NRC COMMENTS
ON
DOE DRAFT ENVIRONMENTAL ASSESSMENT
FOR THE
HANFORD SITE

March 20, 1985

HANFORD
DRAFT EA REVIEW CONTRIBUTORS

Figure 6-1 : Approximate locations within the reference repository location of some present and former liquid waste disposal sites (based on data from ERDA, 1975).

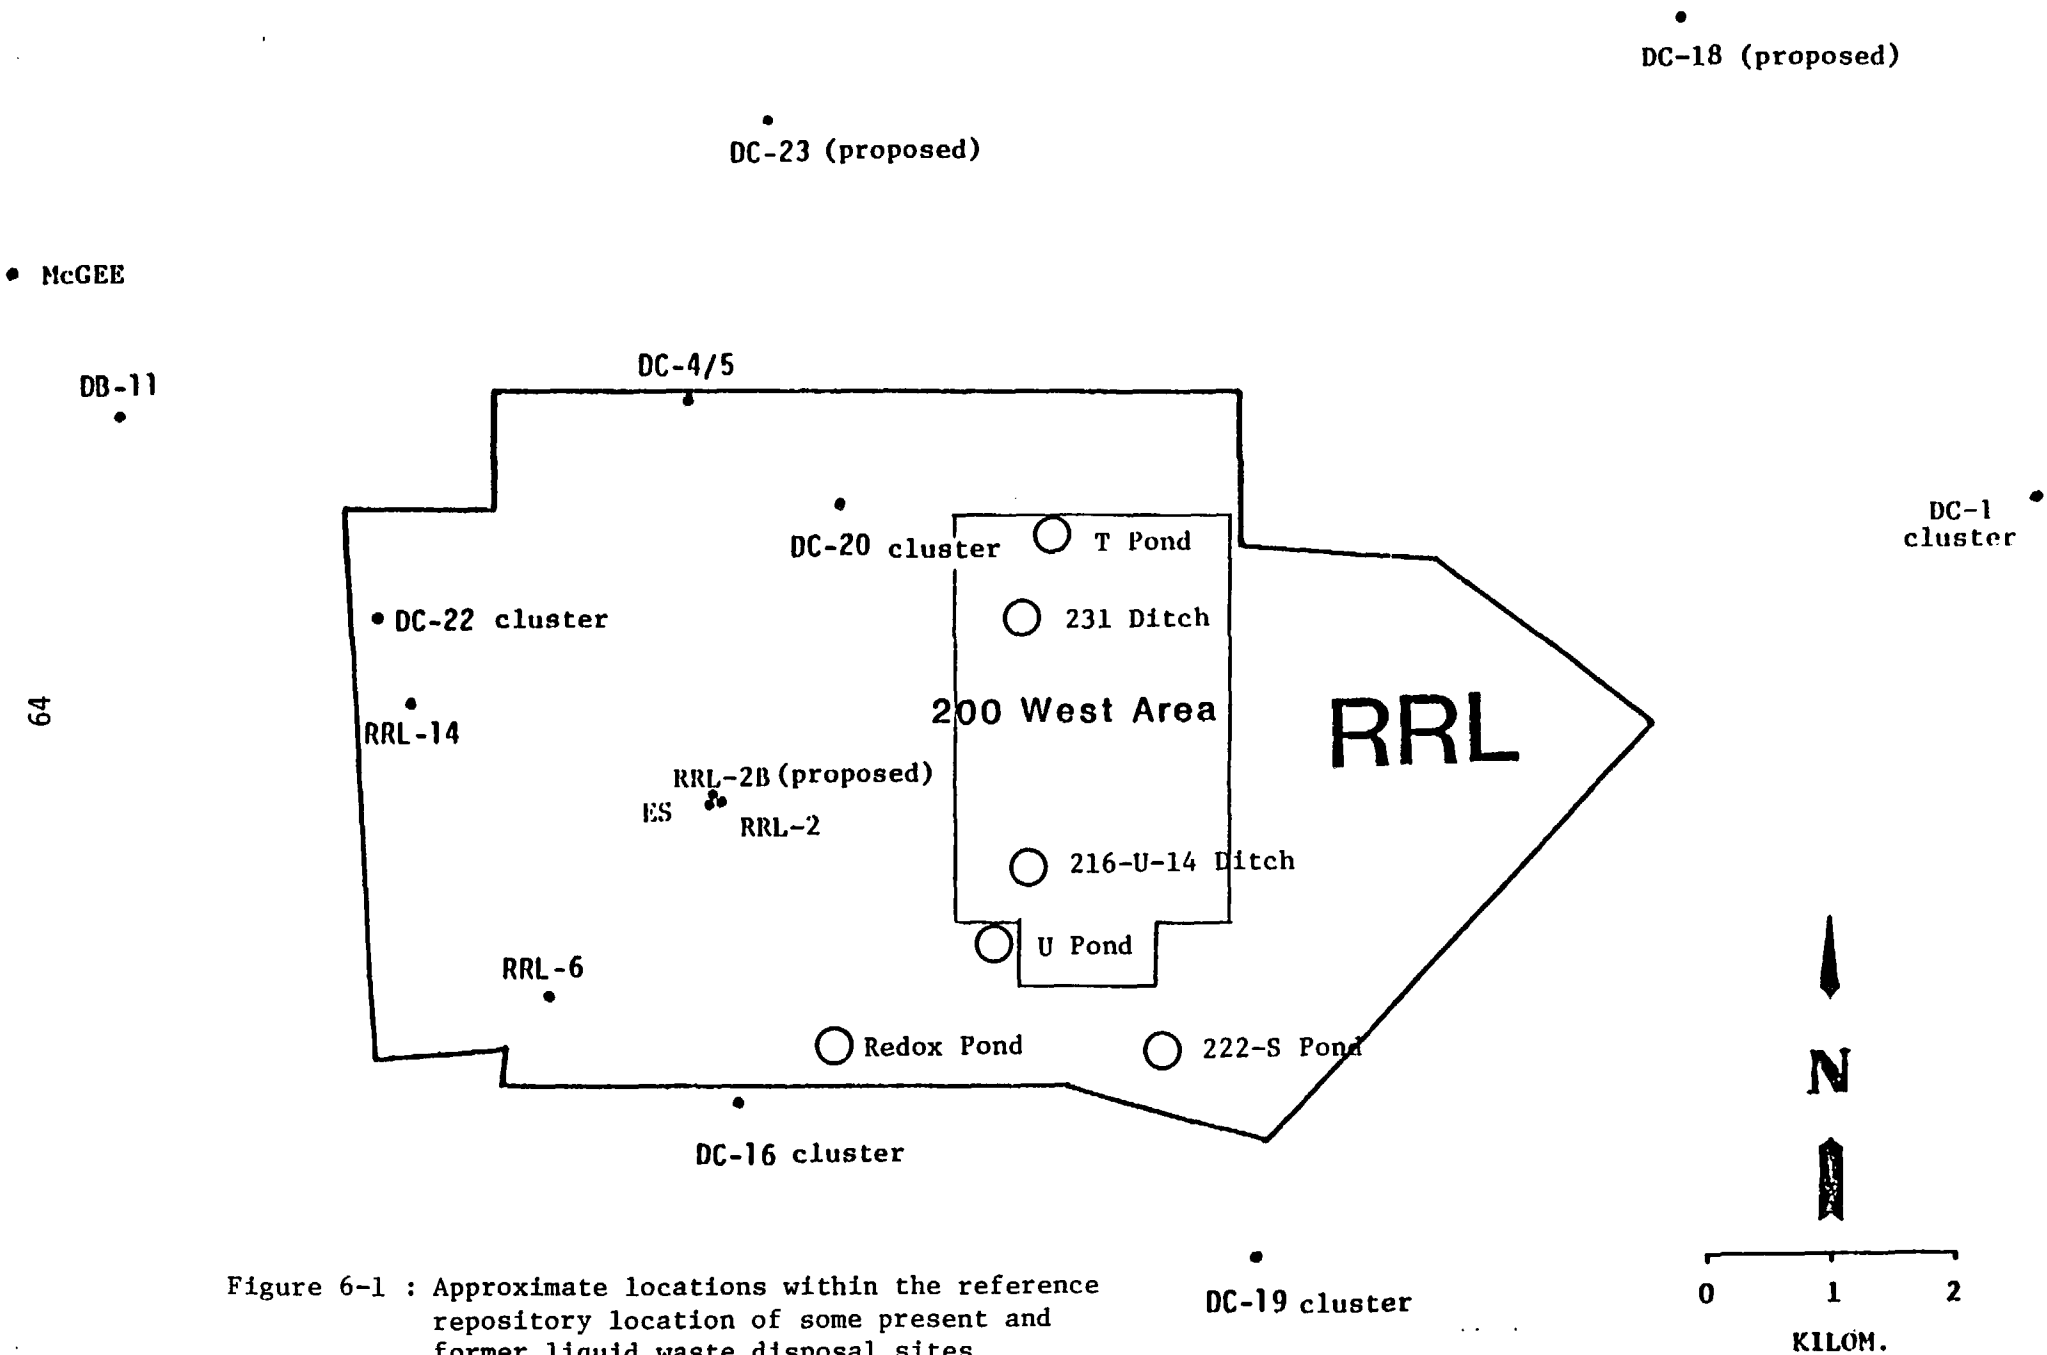
Another possible source of future hydrologic changes is the practice of onsite liquid waste disposal. Disposal activities have been conducted at numerous sites within the reference repository location and have continued at varying discharge rates up to the present. Figure 3-26 on page 3-59 of the draft EA depicts surface water bodies on the Hanford Site and includes the locations of a number of man made ditches and ponds used for the routine disposal of wastewaters. This figure shows only two disposal sites within the perimeter of the reference repository location. However, many more locations within the reference repository location have previously been used as disposal sites. Some of these sites are depicted in Figure 6-1, based on data from ERDA, 1975.

The NRC staff considers that these disposal activities may have caused significant changes in the geohydrologic regime, including the confined aquifers which underlie the reference repository location. Figure 5-41 of the DOE's Site Characterization Report (DOE, 1982) shows 10 hydraulic head measurements collected using drill and test techniques in borehole RRL-2, located in the heart of the reference repository location. According to this Figure, hydraulic heads decrease with depth from the Mabton Interbed down to the upper Grande Ronde basalts, then increase with depth down to the Umtanum Basalt. A similar trend reversal appears to exist in data from borehole DC-16A (Figure 5-40, DOE, 1982). Data from each of the newly constructed (1984) piezometer clusters at DC-19,20,22 also show decreasing heads with depth down to the Priest Rapids member of the Wanapum Basalt.

Figure 6-2. Hydraulic Head Field Realization,
Reference Case Analysis (Clifton, 1984).

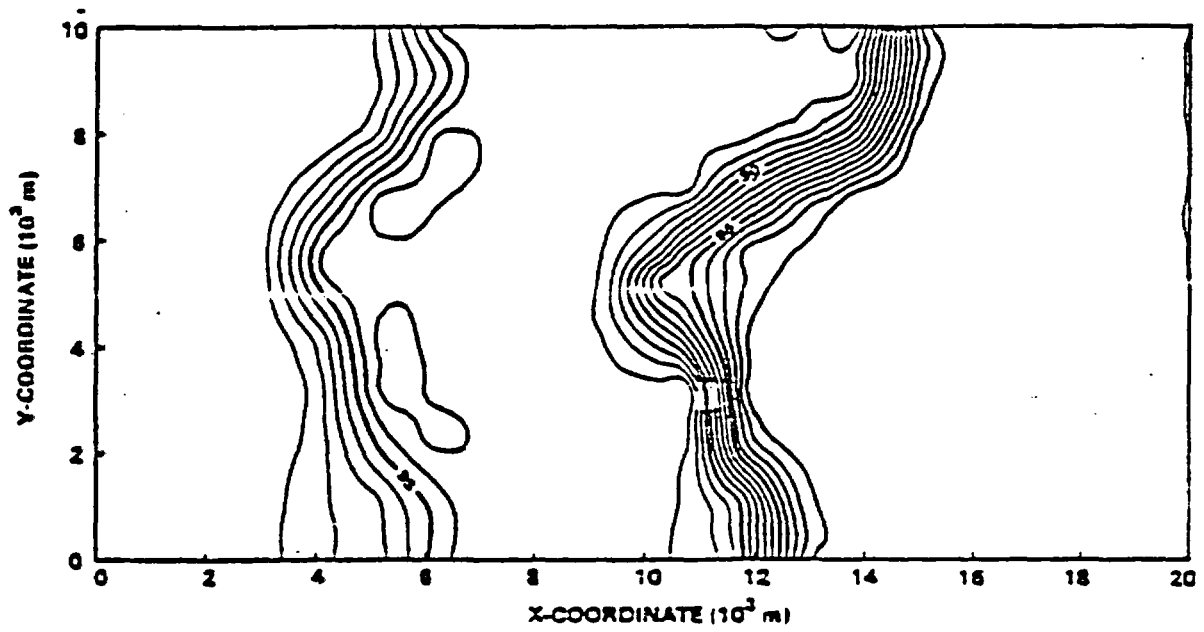
Clifton (1984, p. 30 & 31) also presents example outputs of head configurations based upon model operation. Figure 12 on page 31 (reproduced as Figure 6-2) illustrates a potential problem with the travel time models in the draft EA. The head values show that the model has created a localized zone of low

transmissivity at right angles to the direction of flow. This "damming" effect acts to retard ground water flow and extend travel times. It is unknown whether this plot is representative of model outputs. It is possible that the low transmissivity zone (evidenced by the steep gradient) is created by a combination of the size of the elements, size of the modeled area and size of the correlation range. The NRC staff also notes, regarding this particular figure, that the presence of the closed head contours within the model boundaries appears erroneous, since this would require a source or sink within the model.
